AGENDA  
AEROSPACE SAFETY ADVISORY PANEL MEETING

NASA  
AEROSPACE SAFETY ADVISORY PANEL  
SPECIAL OWS INTEREST ITEM NO. 1

## OWS Flammability Control

Fire Detection System - Panels 529, 530, 618, 619, 633, 638, 639 (61A300026 GFE)

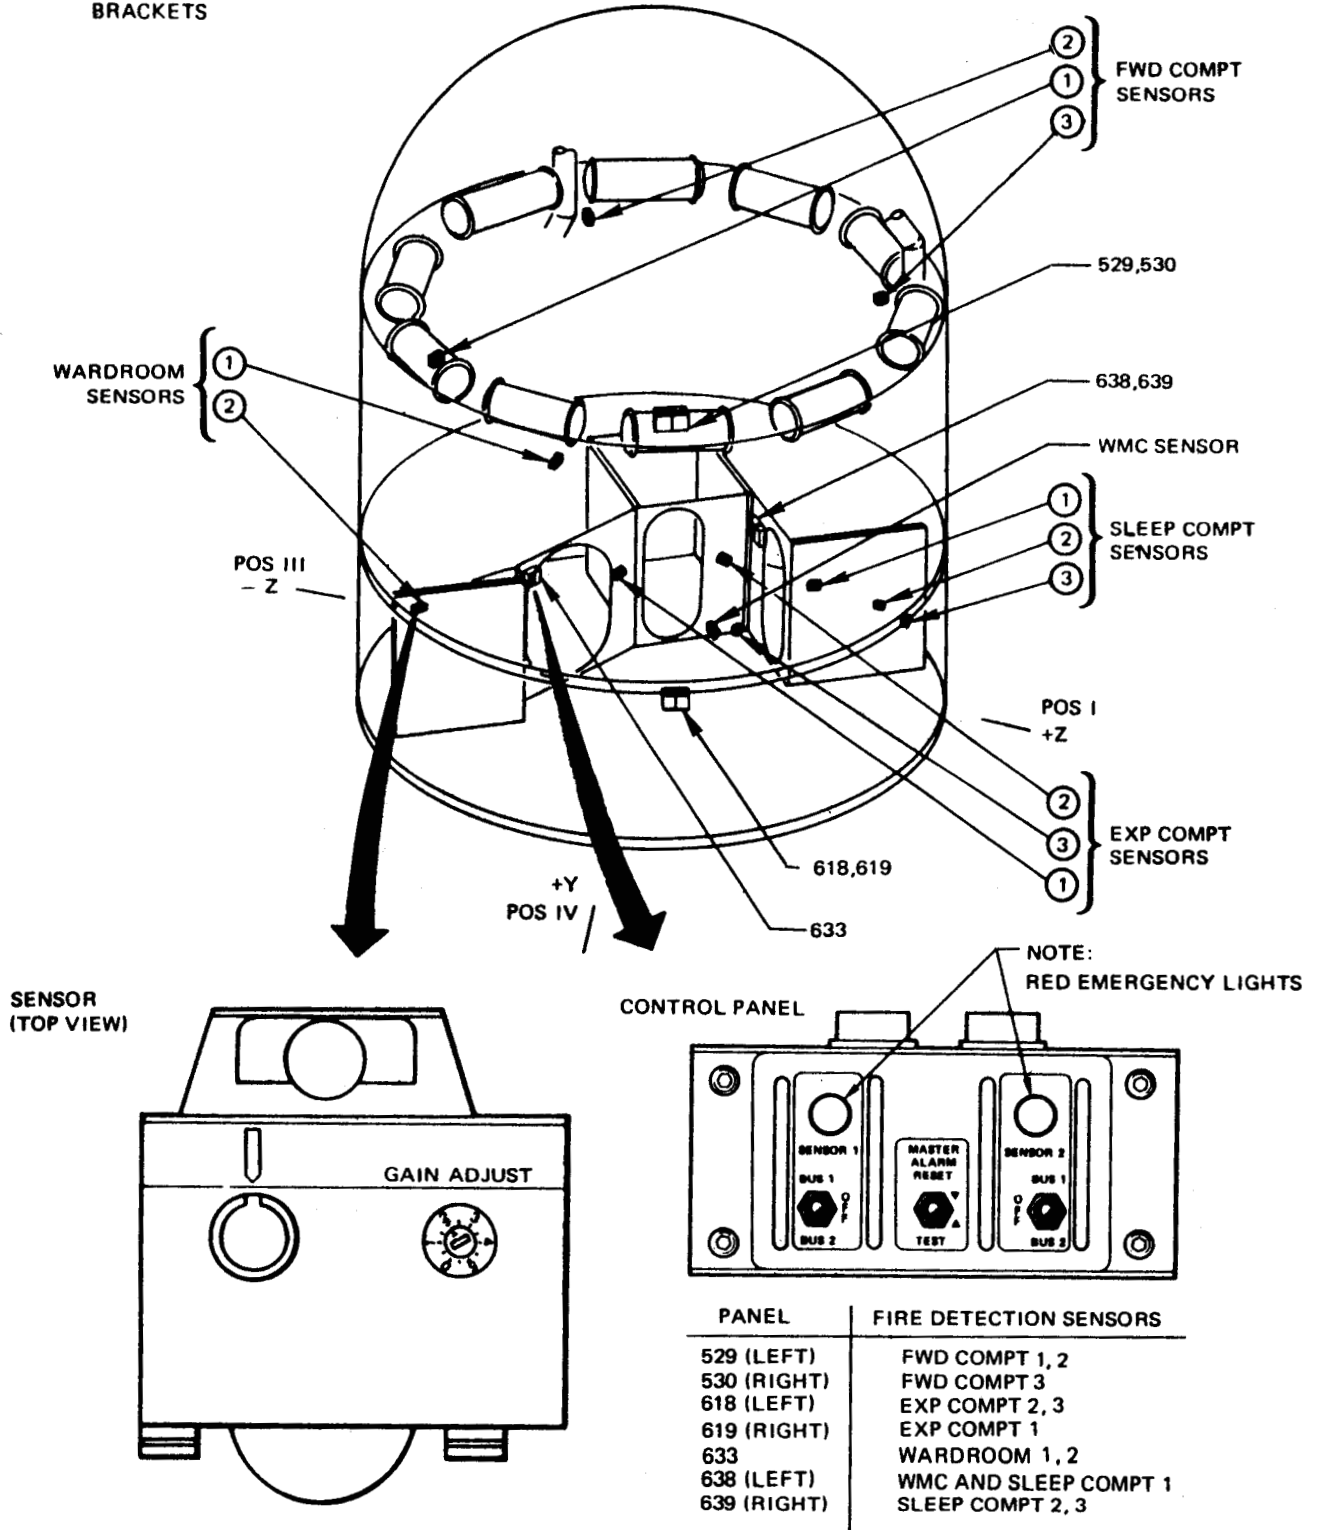
The Panel was quite concerned with the quantity of flammable material which is incorporated in the OWS. We appreciated the reasons given for the necessity of using this material. Since possible fire aboard the vehicle must be considered we would appreciate receiving a fuller description of the on-board equipment and crew procedures which will be used to detect, contain, and extinguish fires if one should start. In this regard we would also like information on studies of the possible effects of toxic materials which might be generated during a fire, damage control, and the establishment of limits of contamination as applied to atmosphere composition.

A fire detection system study was conducted and the results reported in MDC G0095-P, dated 8-20-70. The results of the study indicated that an adequate fire detection system could be achieved by incorporation of an area-type surveillance technique using single coverage ultraviolet detectors.

The OWS fire detection system is comprised of 12 ultraviolet sensors and seven associated control panels. The basic placement and arrangement of sensors and control panels is depicted in Figure 1. Exact locations of the fire detection sensors are defined by drawing No. 1B86999 (January 1971) for all sensors except the Waste Management Compartment sensor which is defined by drawing No. 1B79489 (January 1971).

The above locations have been used to determine the approximate area covered by the field of view for each sensor. The sensor field of view is a 120 degree cone and the installation alignment angles are: (a) aft compartment sensors cone centerlines are canted 30 degrees upward from the horizontal for floor mounted sensors and 30 degrees downward from the horizontal for ceiling mounted sensors, (b) forward compartment sensors cone centerlines are horizontal.

The projection of the conical field of view of each sensor on the floor and ceiling of its respective compartment has been established and straight line approximations developed for the intersections with the surrounding walls. This effectively defines the area which would be within the field of view for each sensor. Adjustments in the placement of the sensors were made based on the coverage definitions to provide the most effective viewing position for each sensor.
